May 24, 2000

RE: Review of Wetlands Impacts Resulting from Construction of Temporary Interchange at SR509 and S. 176th Street.

Figure 1. The wetland boundary delineation overlaid on the plan drawing TE-2 of temporary erosion and sediment control plan.

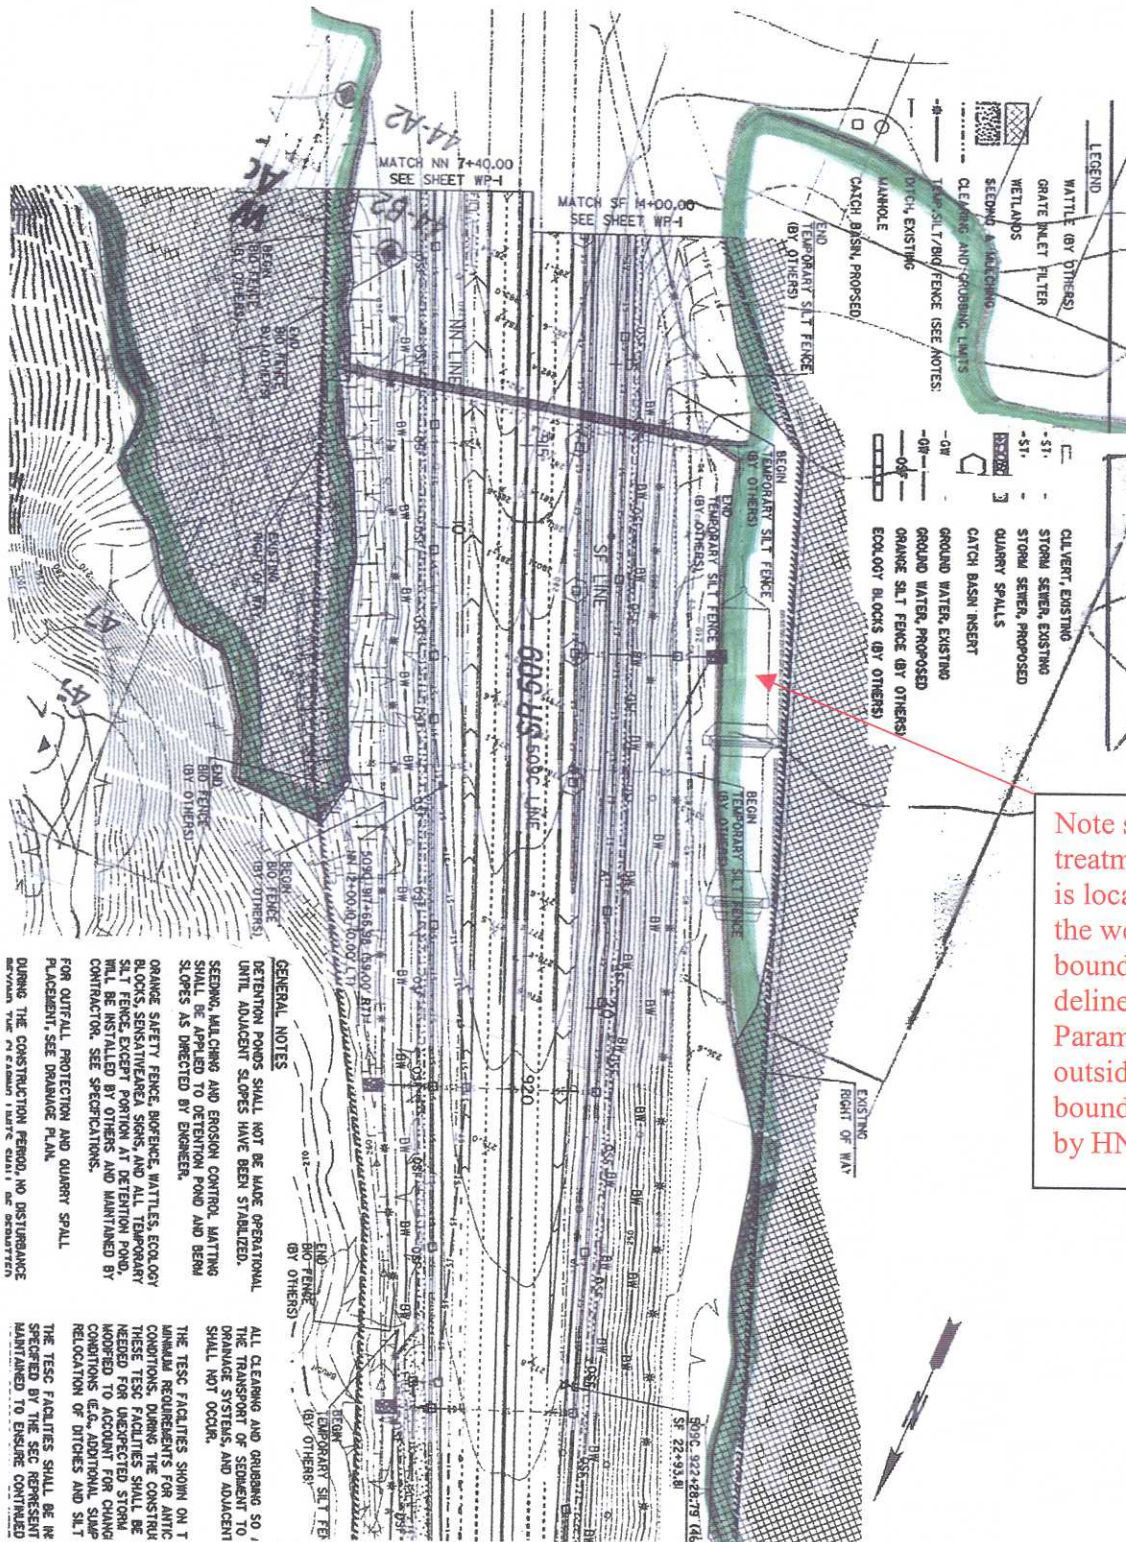
Figure 1 shows the wetland boundary delineation (attached to the May 3rd Parametrix Memorandum) overlaid on the plan drawing TE-2 of temporary erosion and sediment controls. The figure shows that the stormwater facility is actually located in the wetland and the wetland boundary is located on the order of 50 feet closer to the construction zone than discussed in the reporting. Figure 1 also shows contours, which show that the wetland begins at the toe of the fill prism for SR509.

In addition, it is not accepted professional practice to site stormwater facilities in a wetland due to the lack of adequate treatment that results under those conditions. The facility was improperly sited within the wetland. It is unclear from the reporting how the stormwater facility will be used in the future. The wetland should not be further altered for stormwater management purposes.

Note stormwater treatment structure is located within the wetland boundary delineated by Parametrix and outside the boundary shown by HNTB

Figure 2. Aerial photo of construction site showing correct wetland boundary (green shading) in proximity to SR509. (Scale 1"=200 feet)

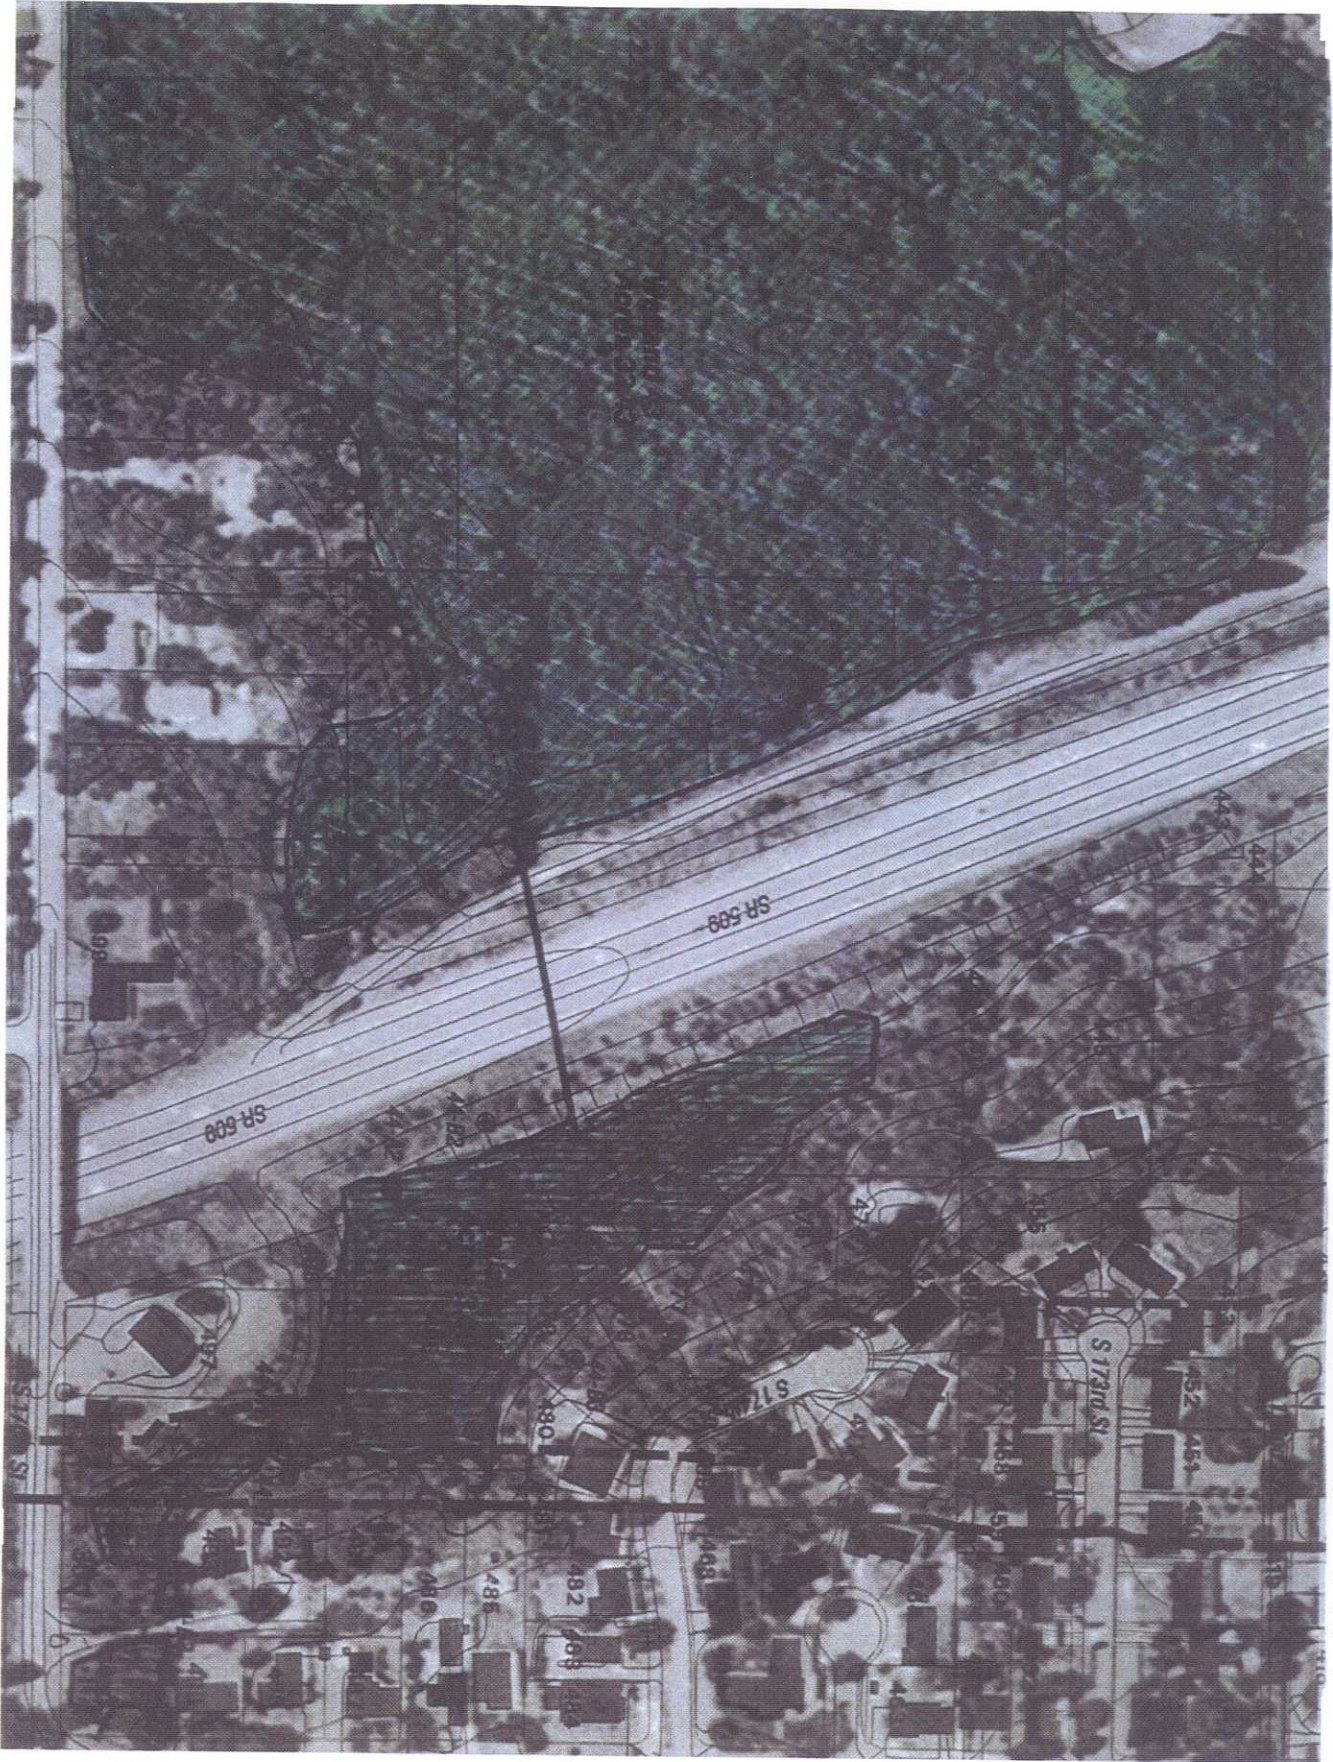
Secondly, much of the construction site adjacent to Wetland 43 is located along a very steep slope, which ends near the wetland boundary. From the shoulder of SR509 moving west in the area shown on Figure 1, there is an approximately 30 foot elevation drop over about 60 feet of lateral distance to an old vegetation encrusted asphalt access road about 12 feet wide. From there the grade drops about 6 feet at 50 percent slope to the boundary of Wetland 43. Figure 2 shows a 1998 aerial photo of the area with the May 5th wetland boundary overlaying the aerial. The photo clearly shows the steep, mixed grass and shrub slope of the highway leading down to the linear feature of the old access road and the wetland boundary immediately adjacent. The dark line crossing SR509 between Wetland 43 and 44 shows the location of the culvert carrying the original drainage course that produced the wetland feature.

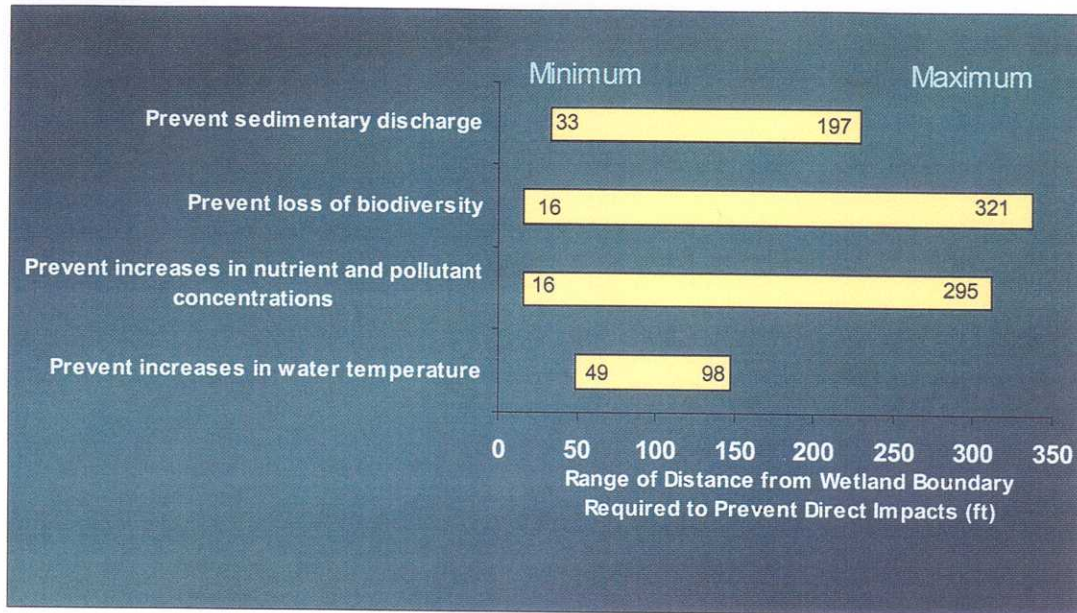
Figure 3 shows results of a scientific review of several studies addressing what area is needed to protect different wetland functions. The first bar shows that discharge of sediment to a wetland requires a distance from the source of a minimum of 33 feet up to a maximum effective distance of 197 feet. Wetlands requiring only 33 feet between the sources of sediment for adequate protection are low quality wetlands with heavily vegetated buffers in flat or nearly flat terrain. Wetlands requiring a distance of 197 feet would be high quality wetlands in steep terrain with poorly vegetated land cover. Wetland 43 is a moderate to high quality wetland (Category 2) in steep terrain, at the base of a highway with a poorly vegetated upland (significant percentage of bare ground between plants). Based on the results of numerous scientific studies, sedimentary discharges to the wetland will occur, given the close proximity of the sediment source (as little as 40 feet in many areas) and the steepness of the upland construction zone.
